Information technology - SCSI Enclosure Services - 2 (SES-2)

This is an internal working document of T10, a Technical Committee of Accredited Standards Committee INCITS (International Committee for Information Technology Standards). As such this is not a completed standard and has not been approved. The contents may be modified by the T10 Technical Committee. The contents are actively being modified by T10. This document is made available for review and comment only.

Summary of Comments on SCSI Enclosure Services - 2 (SES-2)

Figure 3 — Attached enclosure services process

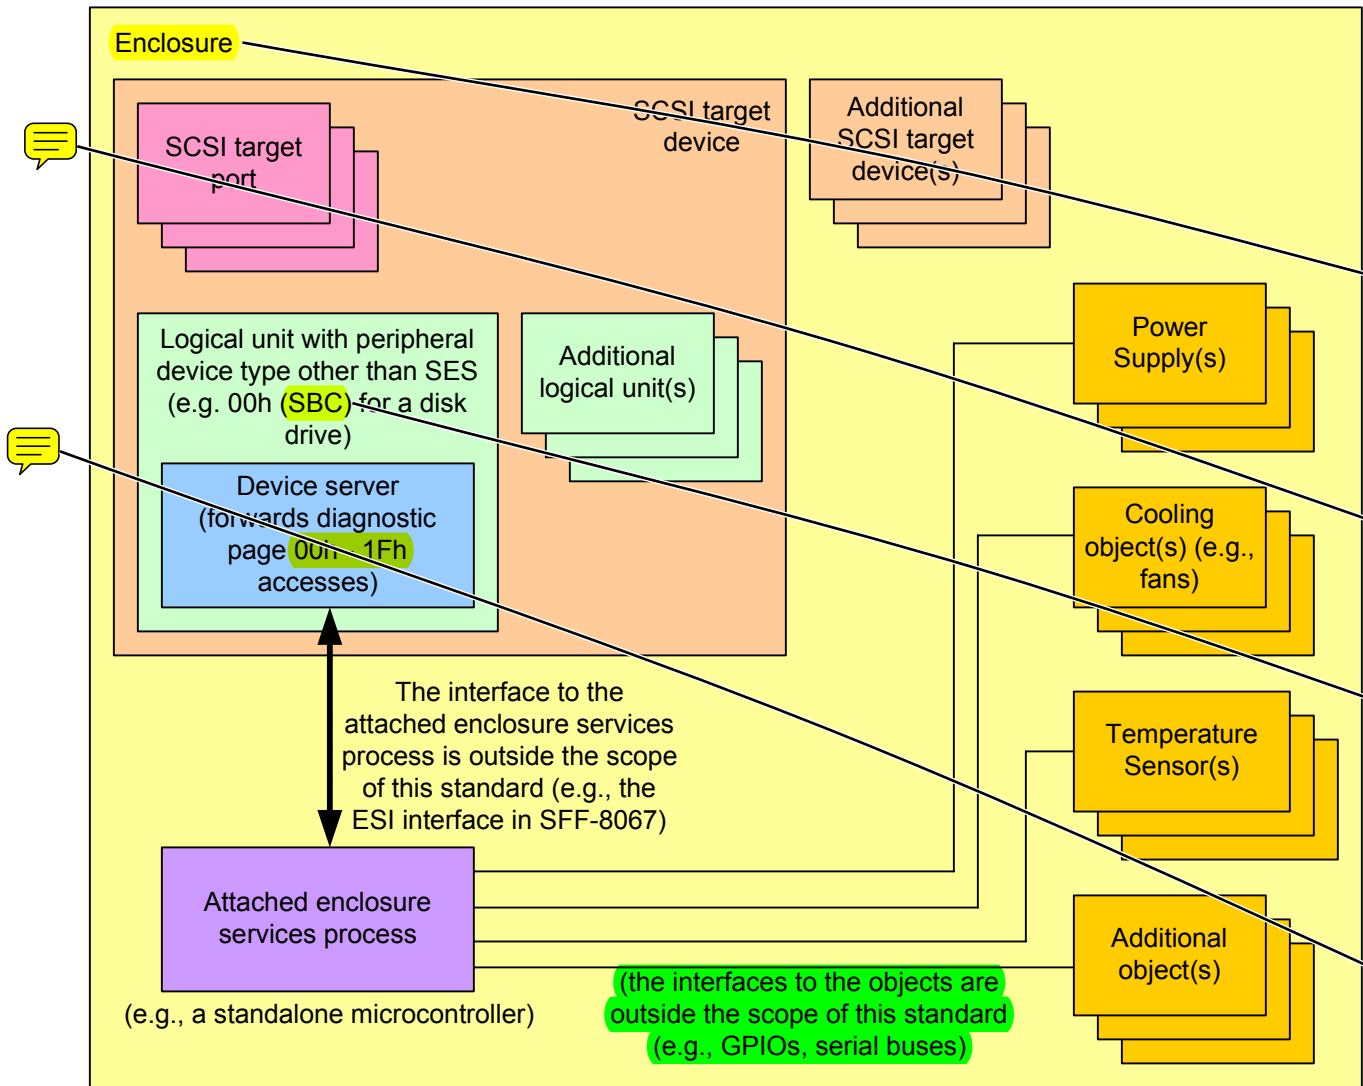
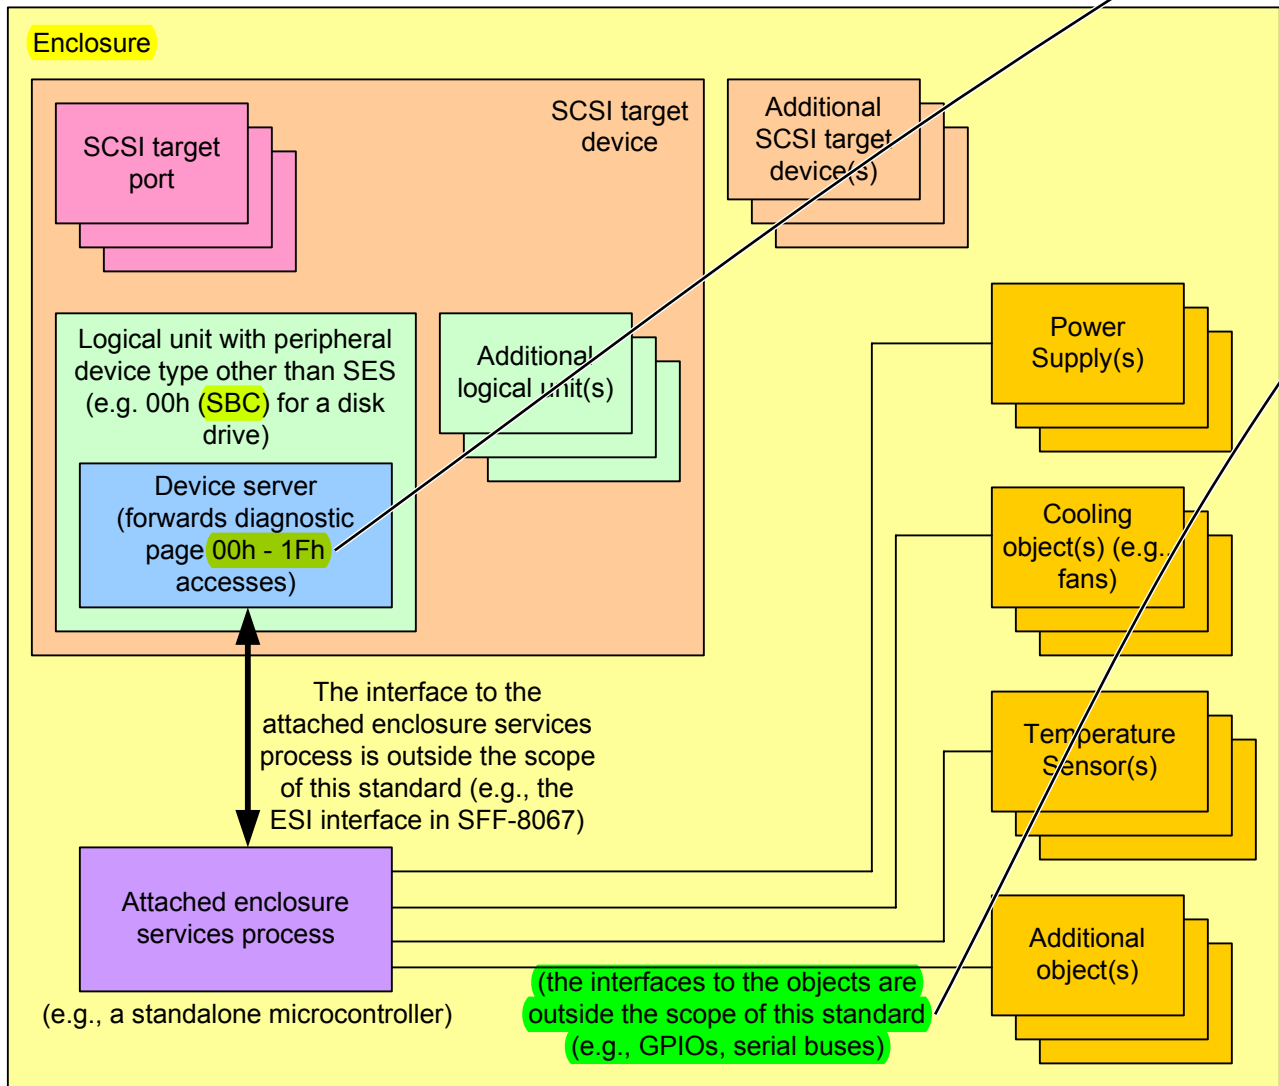
● Author: relliott
Subject: Note
Date: 1/2/2008 7:32:55 PM -06'00'
 Show the enclosure boundary not wholly containing the SCSI target device

● Author: symc-roger
Subject: Note
Date: 12/13/2007 8:25:13 PM -06'00'
 SYMANTEC 11
PDF pg 28, pg 10, Figure 3

Figure 4 — Subenclosures

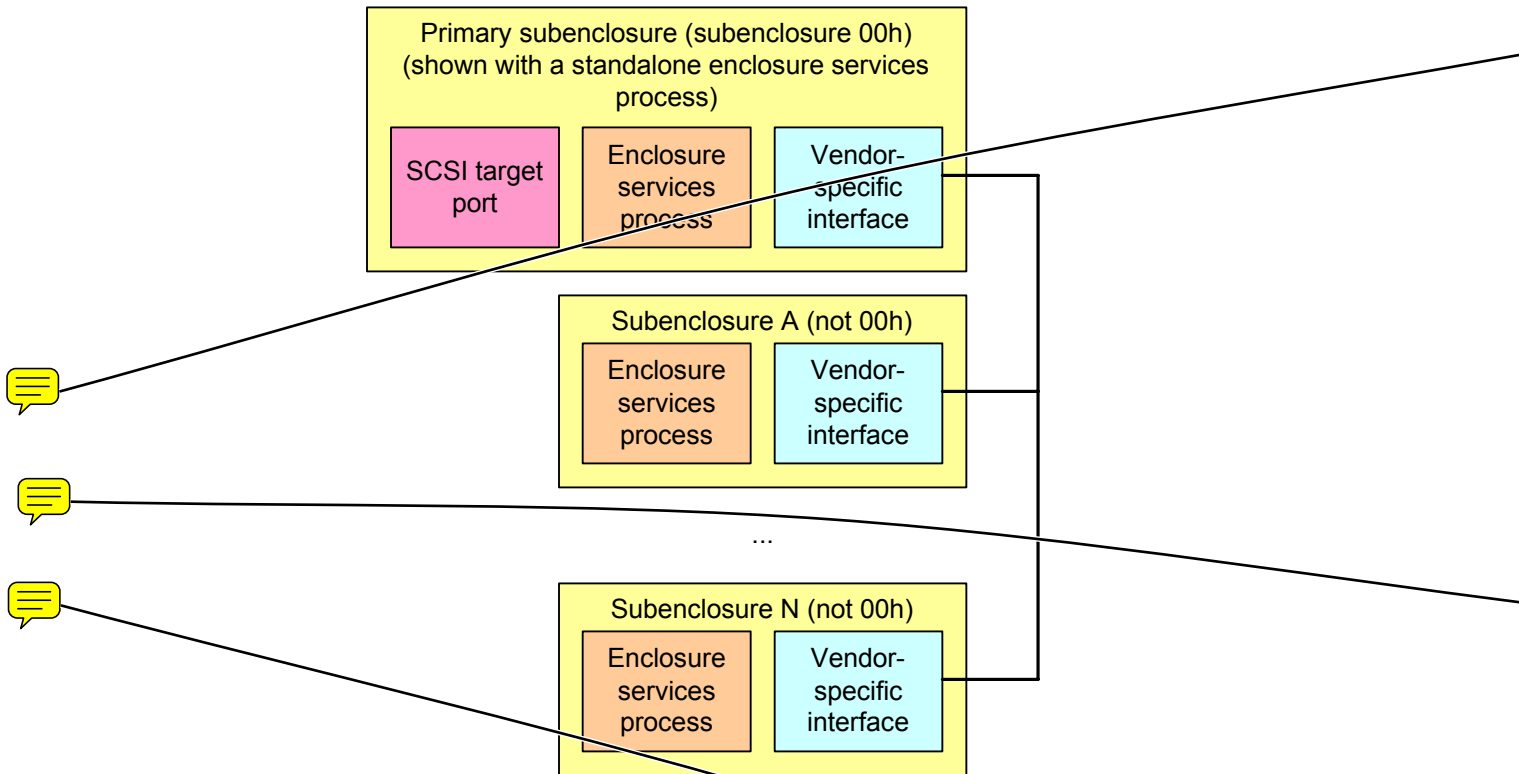
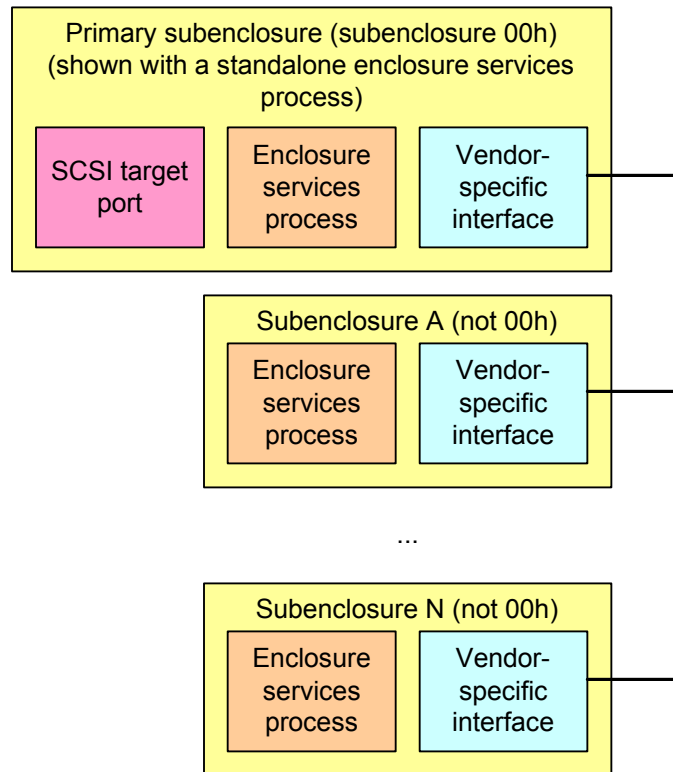
● Author: symc-roger
Subject: Note
Date: 12/13/2007 8:25:13 PM -06'00'
 SYMANTEC 18
PDF pg 31, pg 13, Figure 4

The enclosure descriptor of the configuration diagnostic page supports multiple enclosure service processes per subenclosure, and this should be reflected in the figure.

● Author: symc-roger
Subject: Note
Date: 12/13/2007 8:25:13 PM -06'00'
 SYMANTEC 19
PDF pg 31, pg 13, Figure 4

The figure is the only place that indicates that the subenclosure identifier of the primary subenclosure should be 00h.

Also, added a Enclosure box to the figure surrounding all the subenclosures.

added new section and new figure showing that. It's too complicated to overlay that with multiple subenclosures (which would then demand that standalone/attached be included as well).

Prepend the following sentence to the second paragraph after the figure: "The subenclosure identifier of the primary subenclosure shall be 00h."
